Attachment B  
Response to Comments

Green Valley Road/ Weber Creek Bridge  
Replacement Project  
(CIP #77114)

## Comments and Responses on the Green Valley Road at Weber Creek Replacement Project Initial Study/Mitigated Negative Declaration

Figure 4. Biological Resources Map

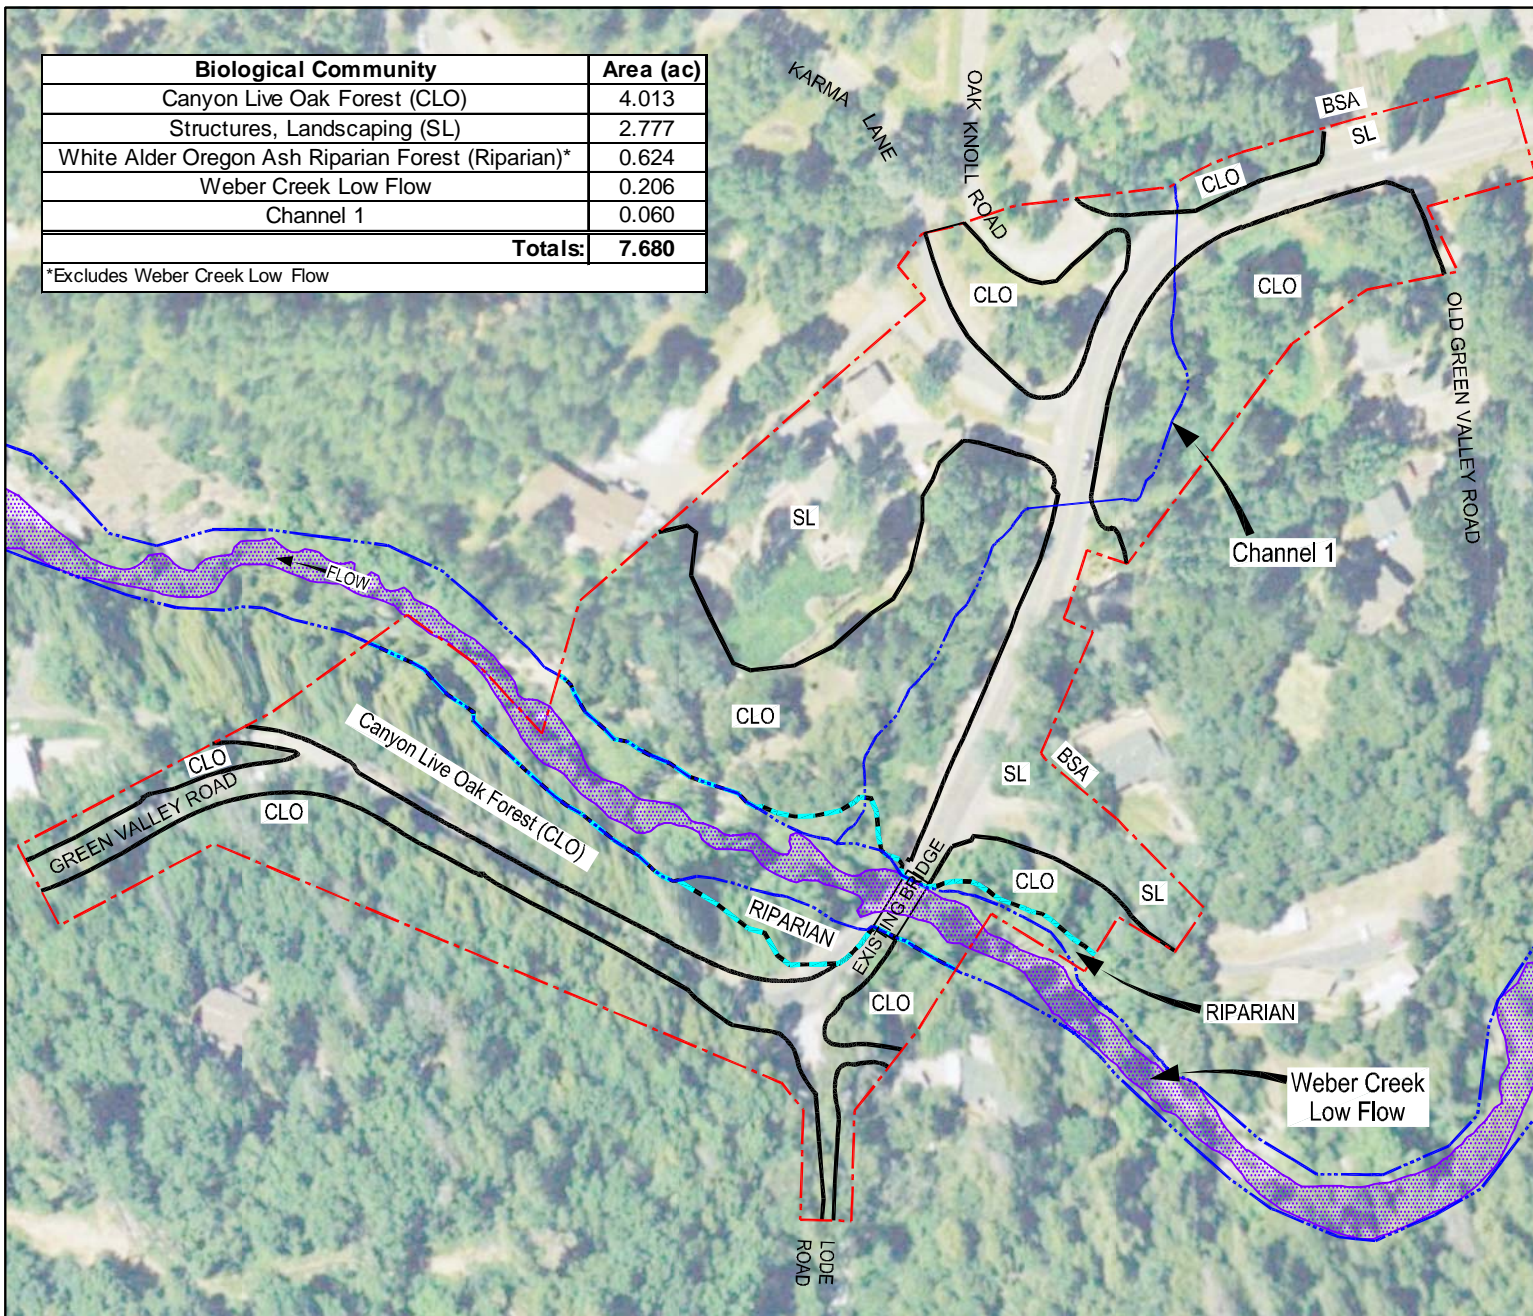
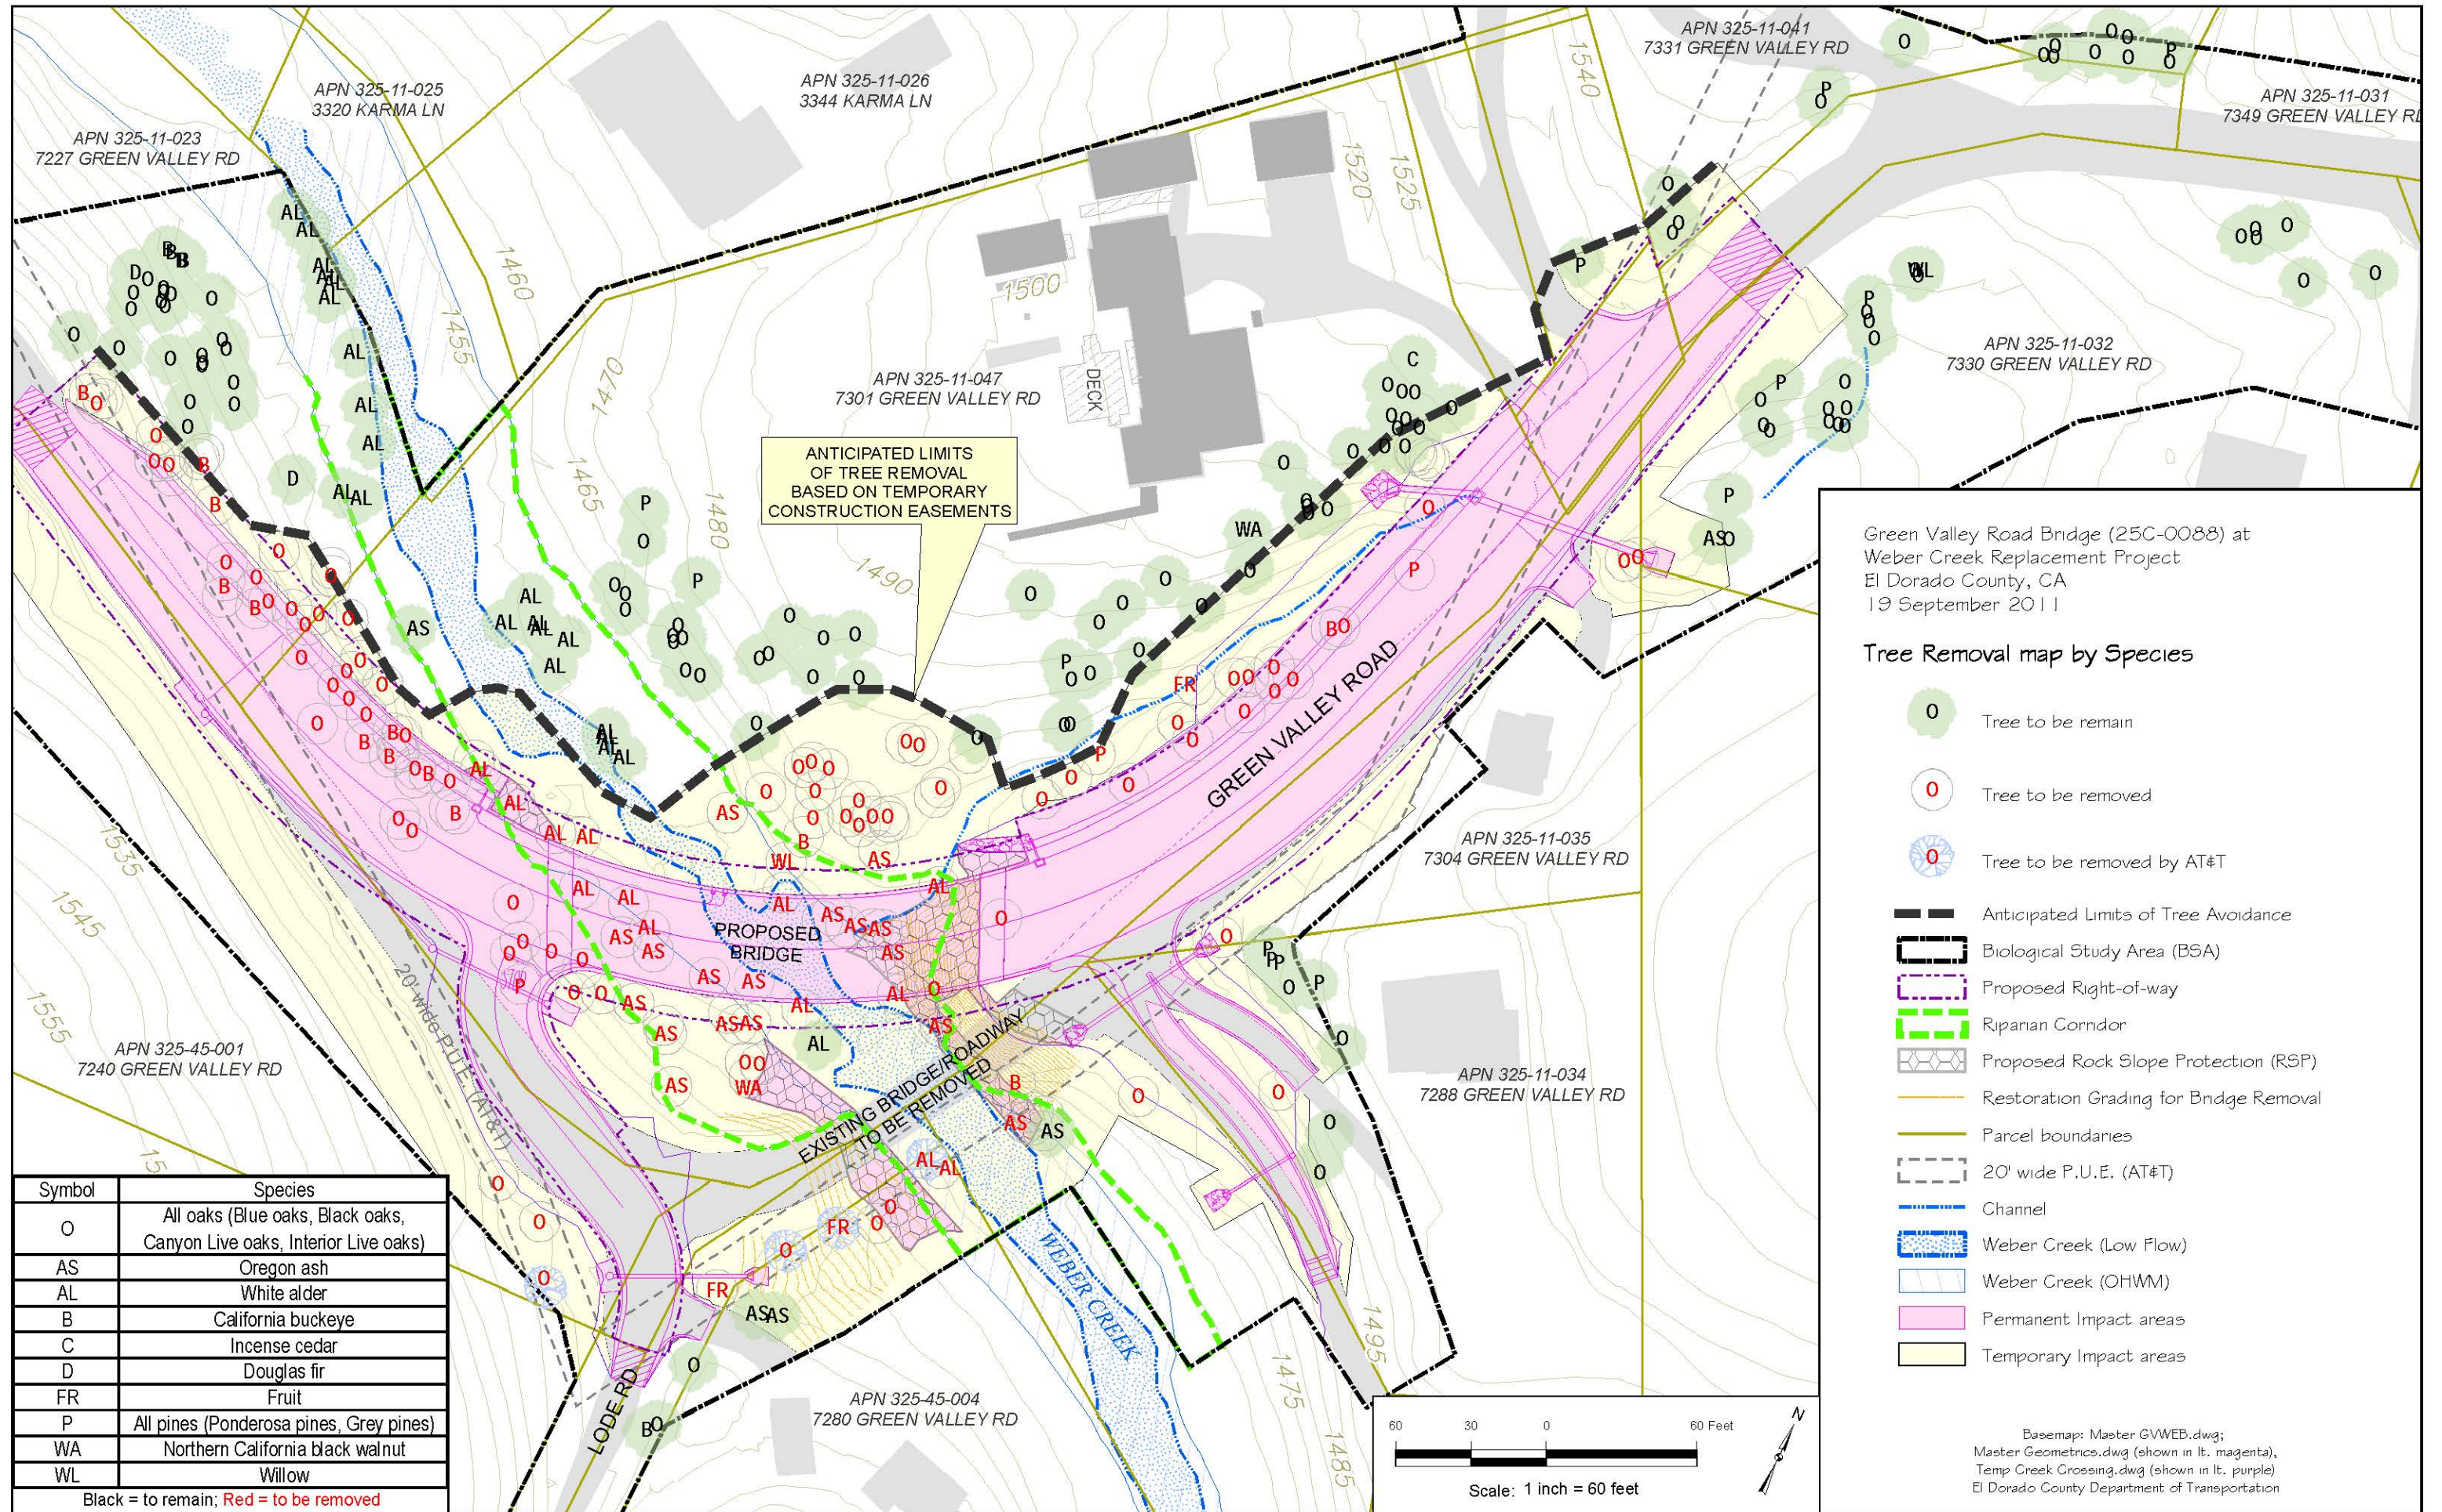
- 1b
- 1c
- 2a 2. **Item 2.3 Project Description-MND-3:** The statement “All native riparian trees in the white alder-Oregon ash riparian forest that are removed will be replaced at a 2:1 ratio. Willow and/or alder canes will be planted in disturbed upland areas” is very confusing to the readers! What is defined as a native riparian tree? What is the white alder-Oregon ash riparian forest? What is considered as “upland areas”? There are further questions on the tree removal and replacement further in this document.

Figure 4 of NES shows the limits of the different biological communities in the project area. It is attached to this response. The NES, page 46, describes the white alder-Oregon ash riparian forest as follows:

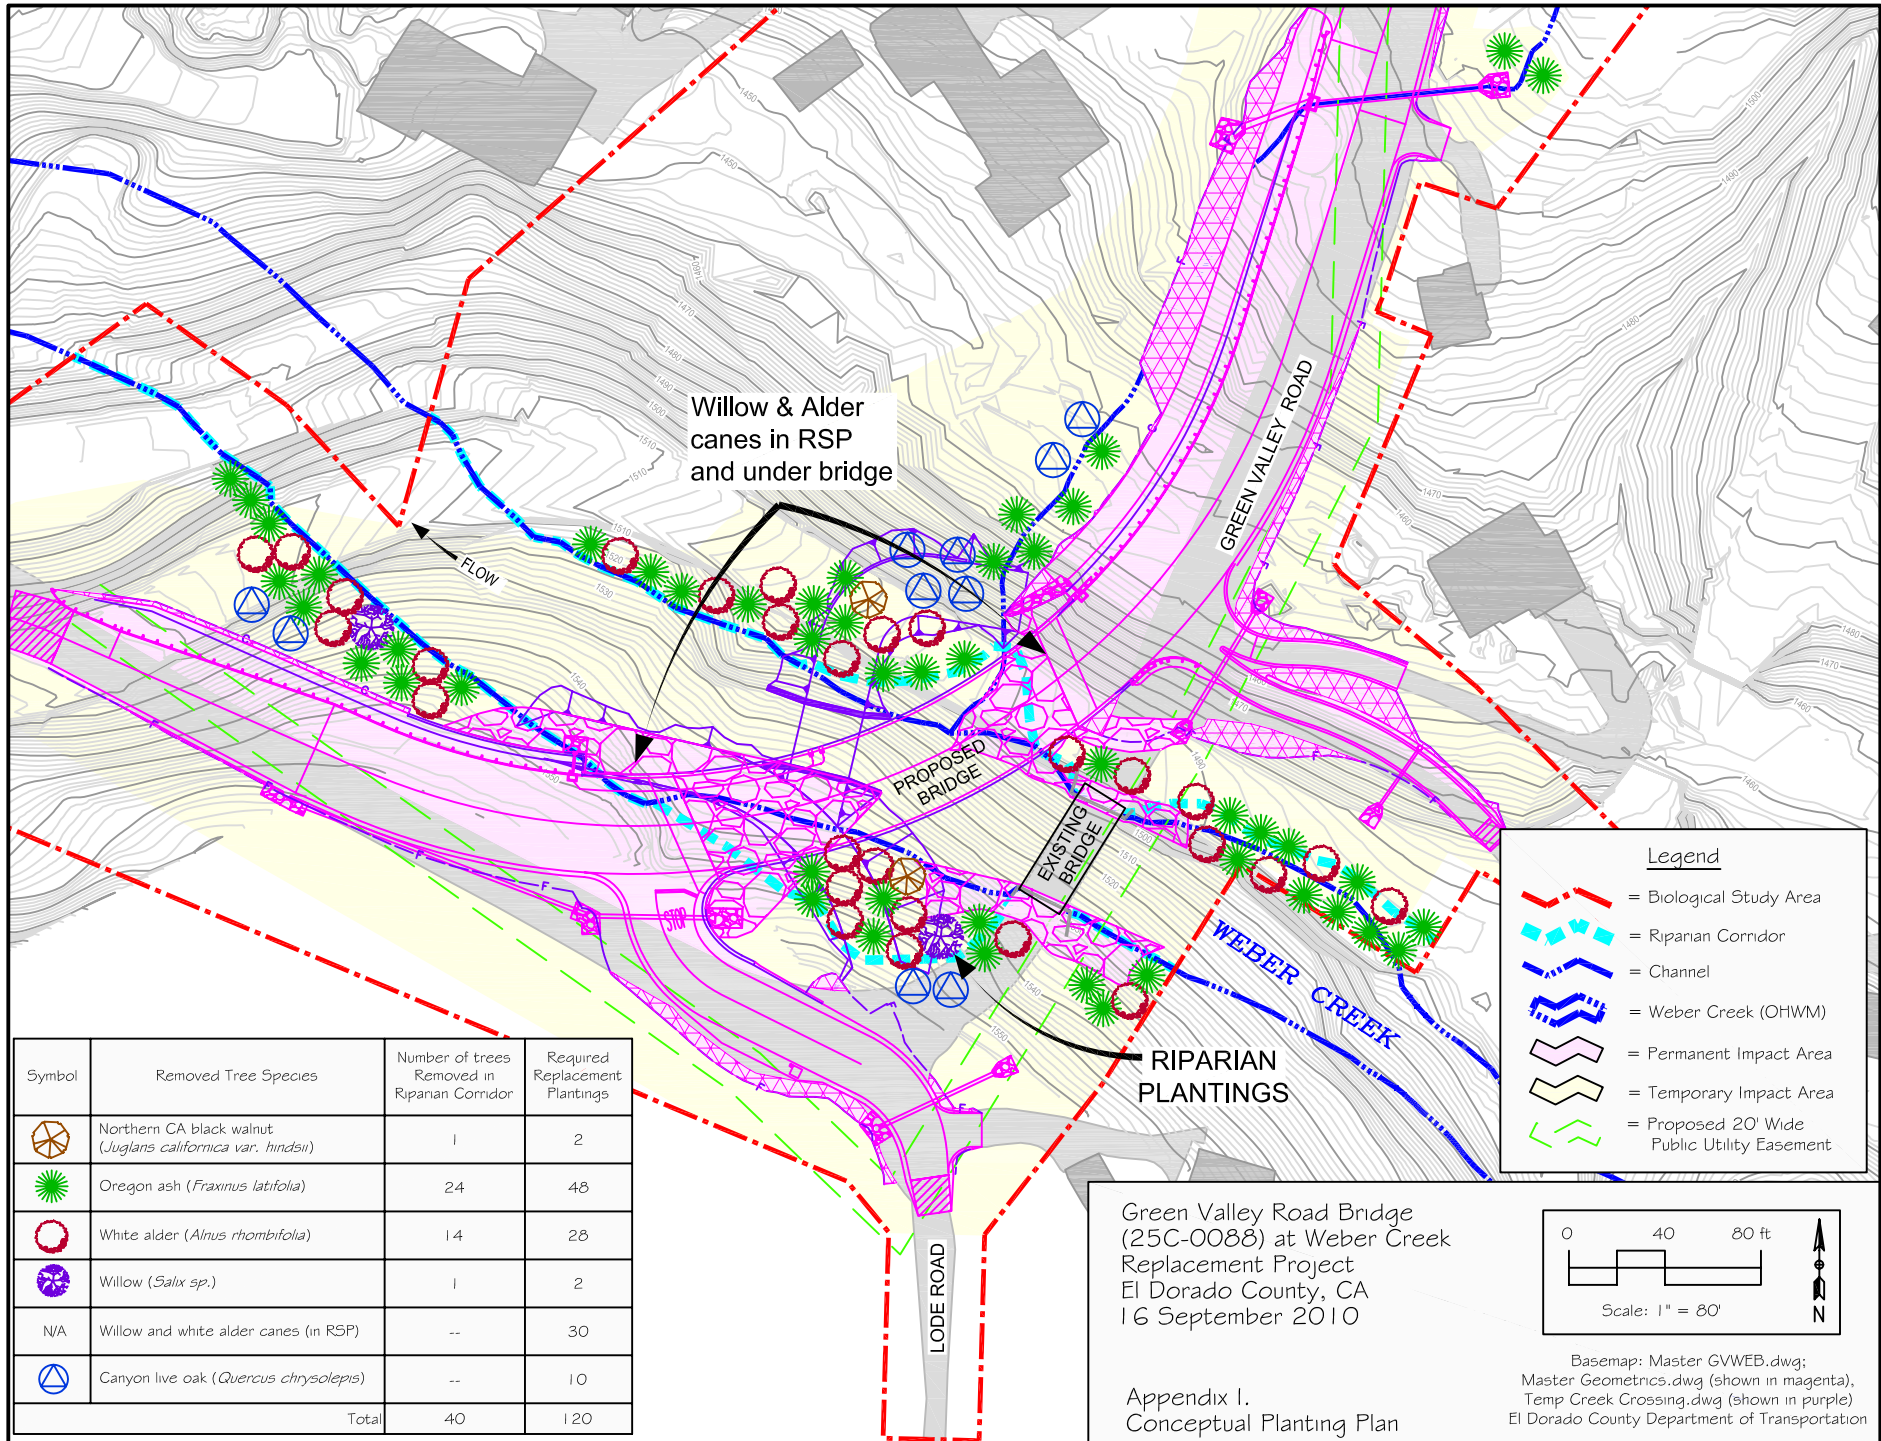
- 3b
- 4 4. **Item 3.2 Setting, Impacts, and Mitigation Measures-MND-24:** Aesthetics –(C) The statement “Substantially degrades the existing visual character or/and quality of the site and its surroundings” is under rated. It is viewed by the owners that the removal of the great amount of tree and the raising of the road and the bridge 11 feet will have major negative permanent impact from our home, back deck, lawn, 30 ft. fish pond, with multiple water features, sanctuary. The removal of the major numbers of large tree removal and replaced by the minimal sized trees will have a major negative impact that will not be recovered in our life time. Be realistic in this area!

The attached "Tree Removal Map by Species" shows, on a single map, the anticipated tree removal information that was shown on the six sheets of Figure 5. The attached map labels the tree species. The map shows that mature trees will remain between the road and the house from the driveway down to the creek. The retained mature trees will continue to provide a visual screen between the road and the house, back deck, lawn, and fish pond. Most of the trees to be removed are located on the south side of Weber Creek.
